ADDENDUM NO. 2

Date: March 3, 2010
Project: 401 S. Tustin Street
Project No.: 100-042-042-042-P210-4200

(A) BUILDING 3 - FOUNDATION PLAN
1/8" = 1'-0"

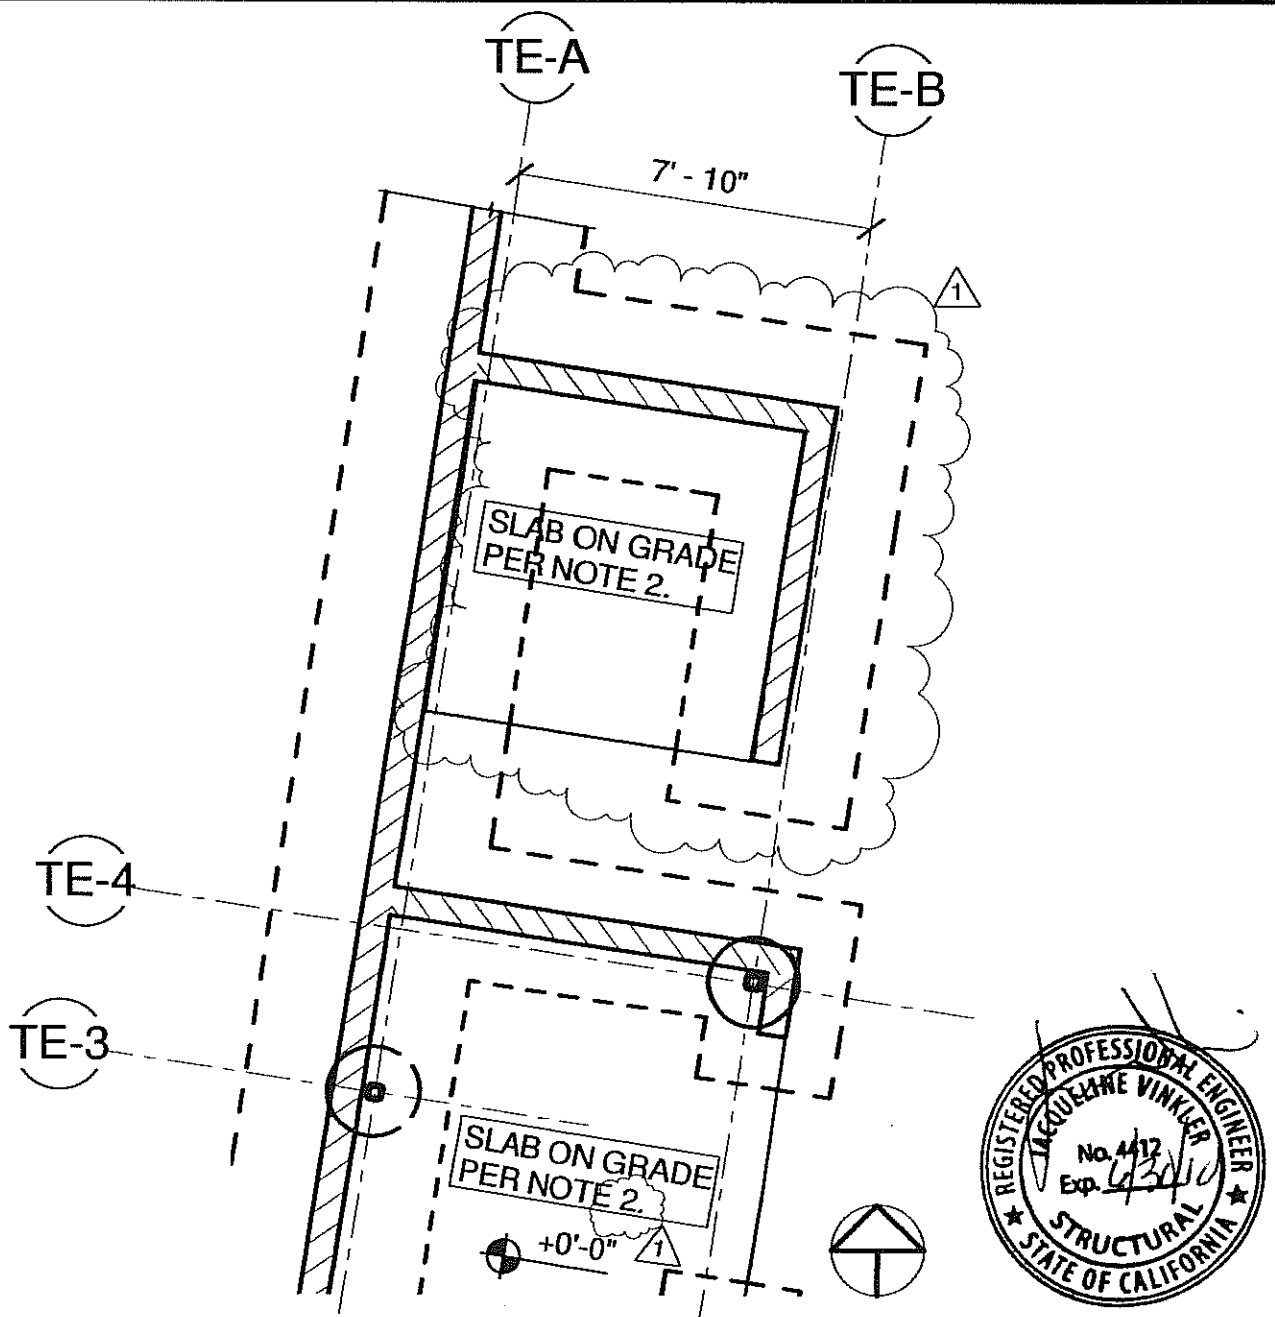
- A. Revise Detail A – Building 3 – Foundation Plan. See attached SKS-1.

CANTILEVER COLUMN FOOTING

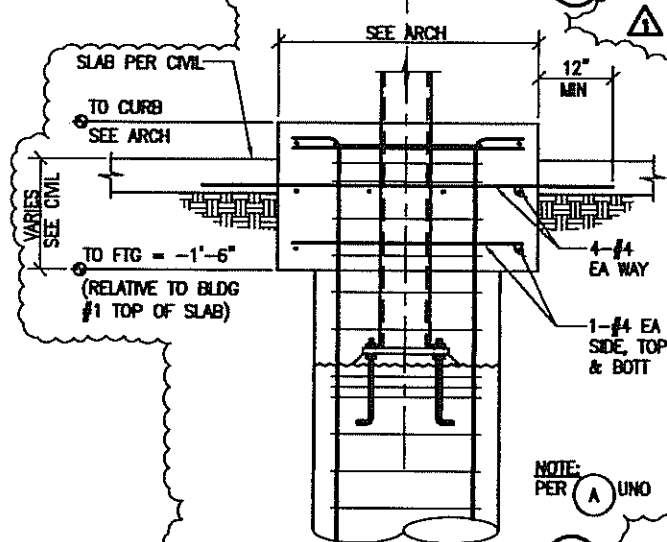
- A. Revise Detail 4 – Cantilever Column Footing Adjacent to CMU Wall. See attached SKS-3.
- B. Add Detail 5 – Footing At Building #3 Architectural Fin Wall. See attached SKS-4.
- C. Revise Detail 6 – Footing Schedule. See attached SKS-5.
- D. Revise Detail 8 – Cantilever Column Footing. See attached SKS-6.
- E. Revise Detail 19 – Freestanding Masonry Wall Schedule. See attached SKS-7.
